ENGINEERING CHANGE NOTICE NO.

05360

DWG NO. 646.9700

DWG TITLE: CUTTER SUB ASSY

SHEET 7, ZONE C3 IS:

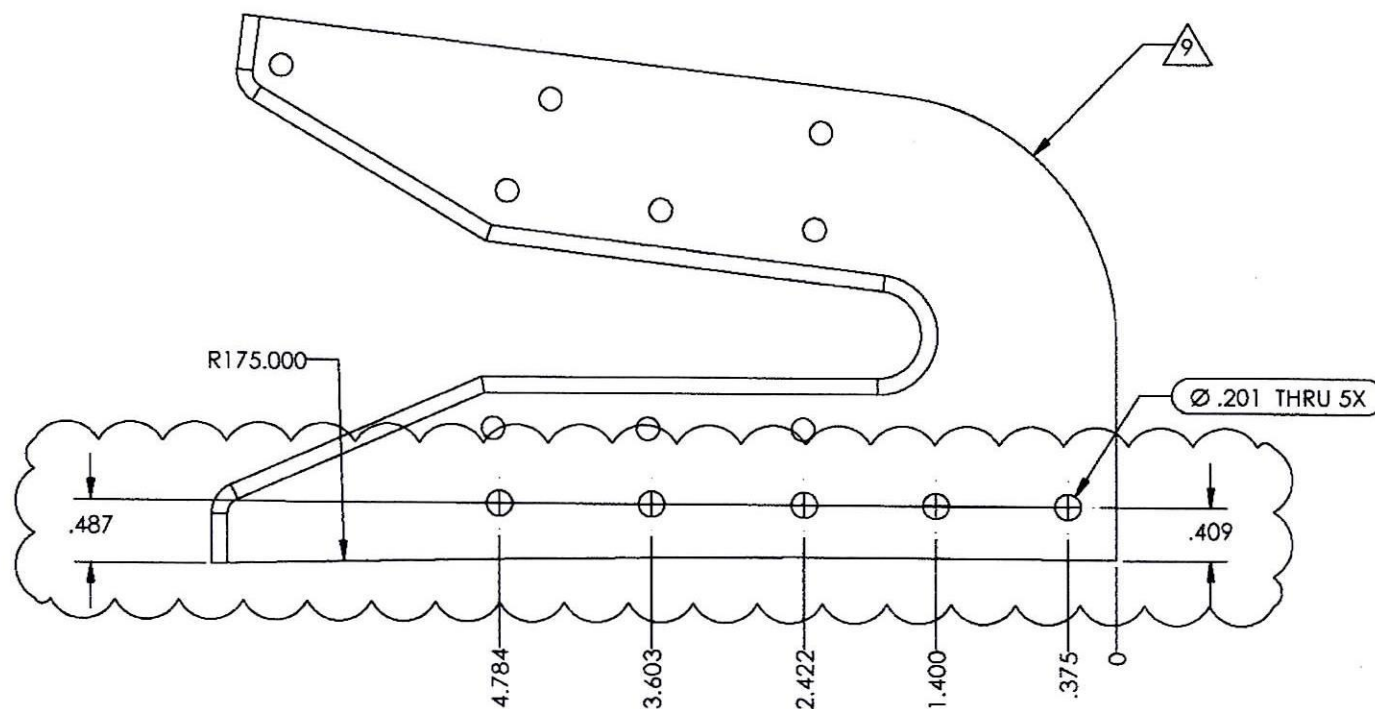
REASON: REVISED DIMENSIONS

SHEET 1, ZONE A6 IS:

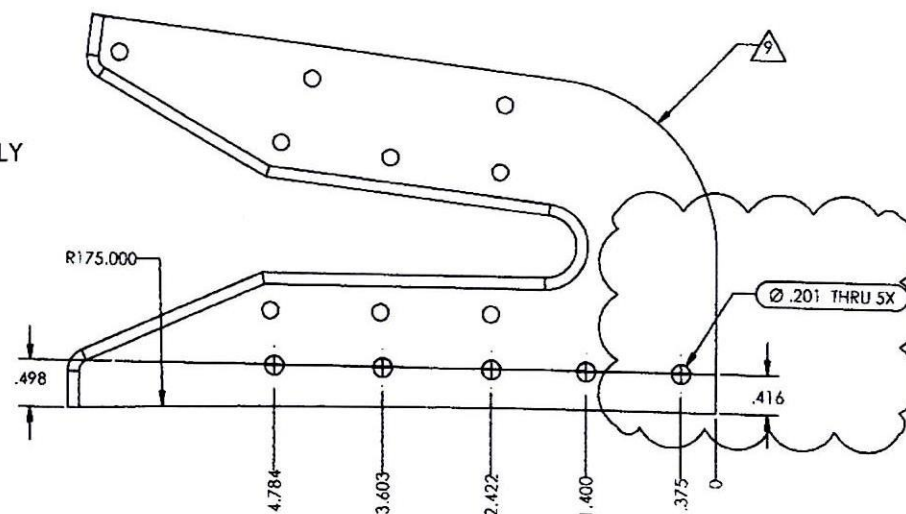
REASON: REVISED NOTES

IS

- 1 MATERIAL: ALUMINUM 7075-T651 PER AMS-QQ-A-250/12
- 2 FINISH IAW MPP-172 SECTION 2.1, 3.3 & 4.3.
- 3 MATERIAL: AISI A2 TOOL STEEL
CONDITION: ANNEALED
POST PROCESS: HEAT TREAT TO 58-62 Rc ROCKWELL HARDNESS
- 4 FINISH: PRIME IAW MPP-172 SECTION 3.3; 1-2 MIL MAX
- 5 DEBURR AND BREAK ALL SHARP EDGES EXCEPT WHERE OTHERWISE NOTED
- 6 IDENTIFY IAW MPP-120
- 7 APPLY F/N 5 AS REQUIRED TO ALL FAYING SURFACES OF F/N 2 UPON ASSEMBLY
- 8 CUTTING EDGE INTENDED TO BE SHARP, DO NOT BREAK SHARP EDGE
- 9 ALL DIMENSIONS NOT SPECIFIED ARE CONTROLLED BY 646.9710.

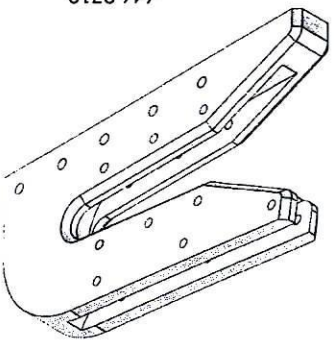
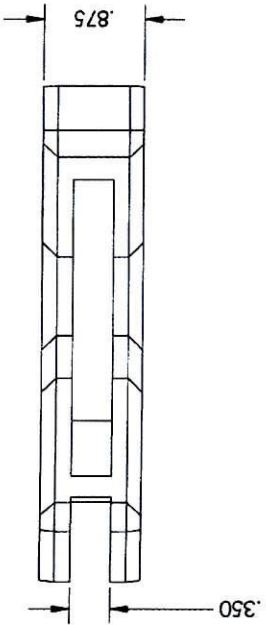
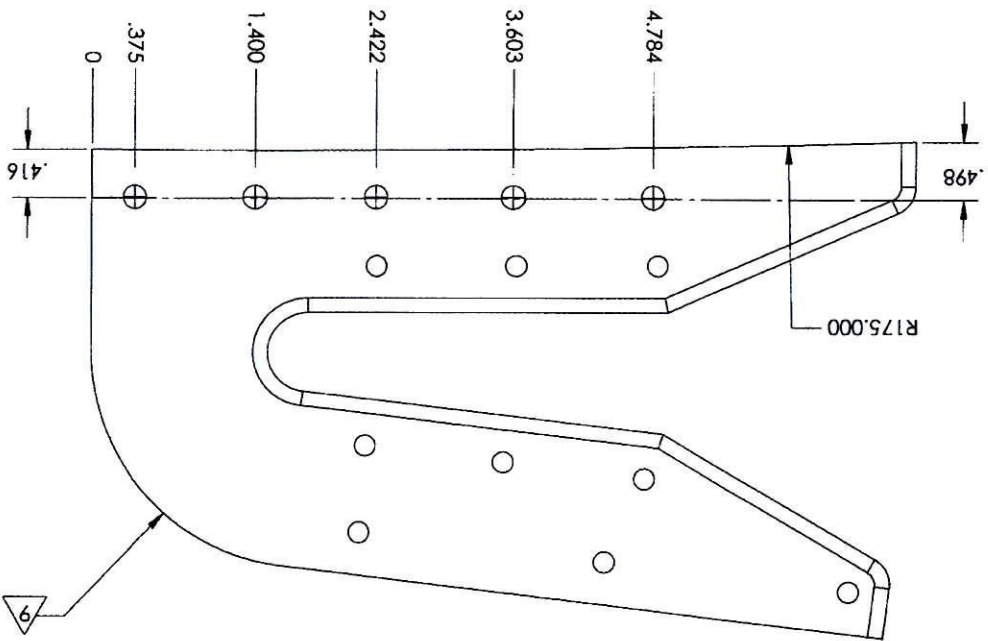
SHEET 7, ZONE C5 IS:
